# HISTORIC AND DESIGN REVIEW COMMISSION

August 19, 2020

**HDRC CASE NO:** 2020-333  
**ADDRESS:** 430 E MULBERRY AVE  
**LEGAL DESCRIPTION:** NCB 3089 BLK 5 LOT NE TRI 50 FT OF 7 & SE IRR 50 FT OF 8  
**ZONING:** R-4,H  
**CITY COUNCIL DIST.:** 1  
**DISTRICT:** Monte Vista Historic District  
**APPLICANT:** Peter DeWitt/Adapt Architecture and Construction  
**OWNER:** Troy Sanders  
**TYPE OF WORK:** Removal and construction of an addition, site modifications, window replacement, demolition of a rear garage, construction of a rear garage  
**APPLICATION RECEIVED:** July 17, 2020  
**60-DAY REVIEW:** Not applicable due to City Council Emergency Orders  
**CASE MANAGER:** Stephanie Phillips

**SANDERS RESIDENCE**

**2** EXISTING GARAGE DEMO  
SCALE: 1/4"=1'-0"

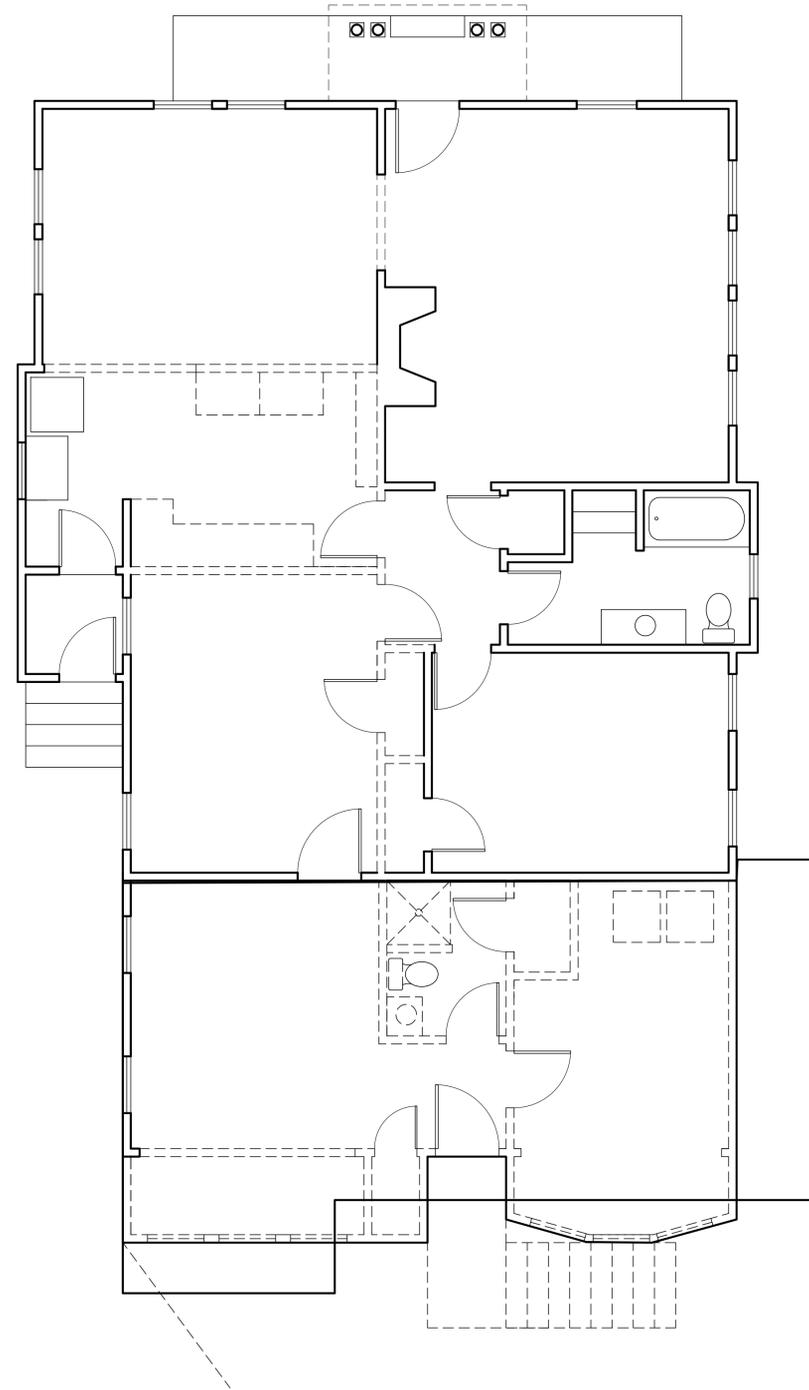
- h. DEMOLITION OF REAR ACCESSORY STRUCTURE – The applicant is requesting approval for the demolition of the rear accessory structure only. In general, accessory structures contribute to the character of historic properties and the historical development pattern within a historic district.

- i. CONTRIBUTING STATUS – The existing 1-story rear accessory structure as a one story, single bay garage structure constructed in 1925 featuring a hipped roof, non-original garage door, and wood windows. The structure appears on the 1951 Sanborn Map. On July 29, 2020, staff conducted a site visit to evaluate the condition of the property. While several original materials exist and the original footprint appears to be intact, the structure has undergone several ill-executed modifications over the years, including opening adjustments

that are causing the structure to separate or collapse in various places. Large portions of the walls have also been replaced or fully reframed due to water damage. The rear roofline is bowed and the existing sharp grade of the site results in rainwater runoff collecting in and around the structure. While staff finds that the structure is rapidly deteriorating, the structure is still contributing to the district.

- k. LOSS OF SIGNIFICANCE – In accordance with UDC Section 35-614(c), demolition may be recommended if the owner has provided sufficient evidence to support a finding that the structure has undergone significant and irreversible changes which have caused it to lose the historic, cultural, architectural or archaeological significance, qualities or features which qualified the structure or property for such designation. Staff finds that a loss of significance may have occurred due to the modifications and substantial deterioration of original materials.

Item 5, Staff recommends approval of the demolition based on findings h through k with the following stipulation:

- i. That materials from the historic accessory structure including salvageable wood siding, structural elements, interior shiplap, wood doors, and wood windows be salvaged and stored for use on site in future construction or donated.

NEW EXTERIOR  
ELEVATIONS

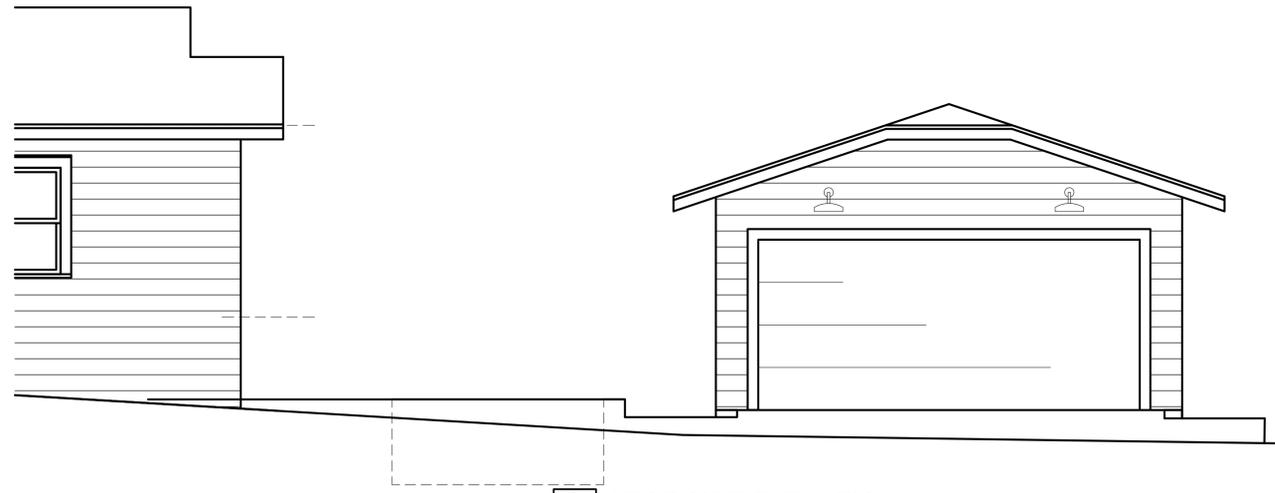
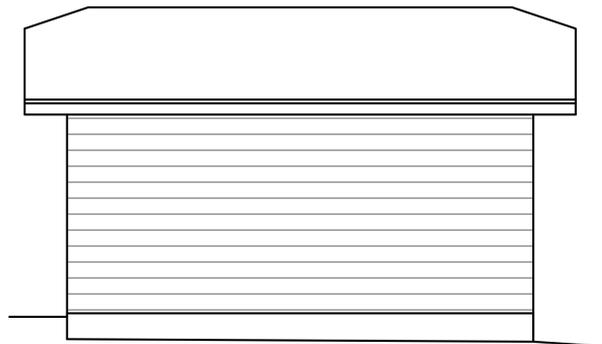
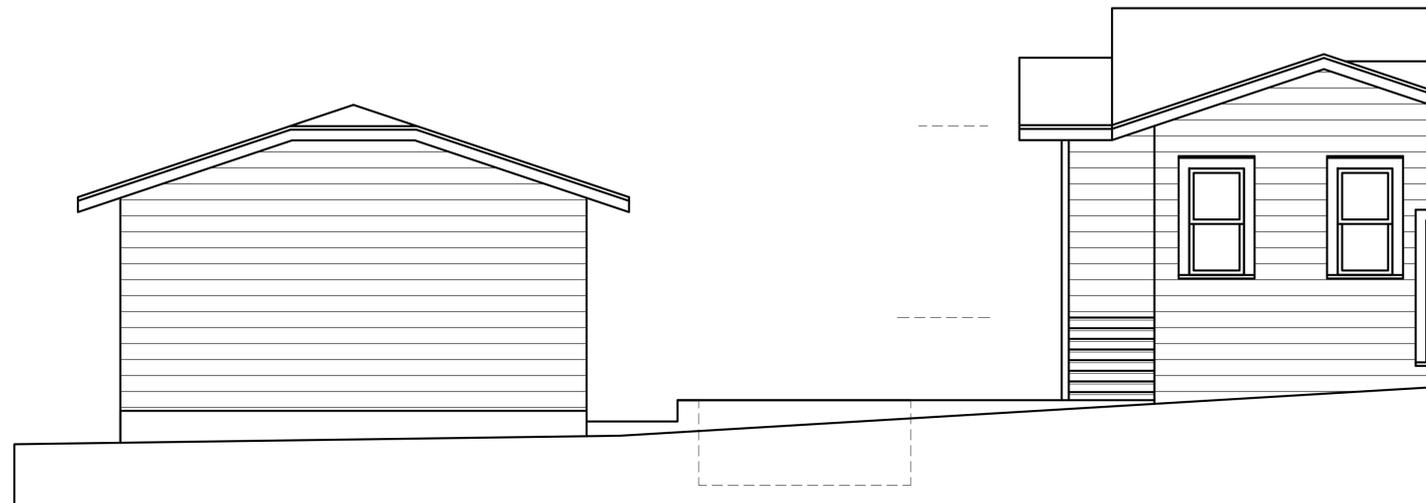
- g. NEW REAR ADDITION – The applicant has proposed to construct a new rear addition in the general footprint of the existing. The addition will feature a side wall plane that closely matches the wall plane of an original side gable on the east façade. The addition will feature materials to match the existing structure, including new one over one wood windows that meet staff's specifications, and will tie into the existing roofline. Staff finds the request consistent with the Guidelines.

Item 4, Staff recommends approval of the rear addition based on finding g with the following stipulations:

- ii. That the windows meet the following stipulations: windows must be fully wood or aluminum-clad wood windows and feature a true one-over-one configuration. Meeting rails must be no taller than 1.25” and stiles no wider than 2.25”. White manufacturer’s color is not allowed, and color selection must be presented to staff. There should be a minimum of two inches in depth between the front face of the window trim and the front face of the top window sash. This must be accomplished by recessing the window sufficiently within the opening or with the installation of additional window trim to add thickness. Window trim must feature traditional dimensions and architecturally appropriate sill detail. Window track components must be painted to match the window trim or concealed by a wood window screen set within the opening.
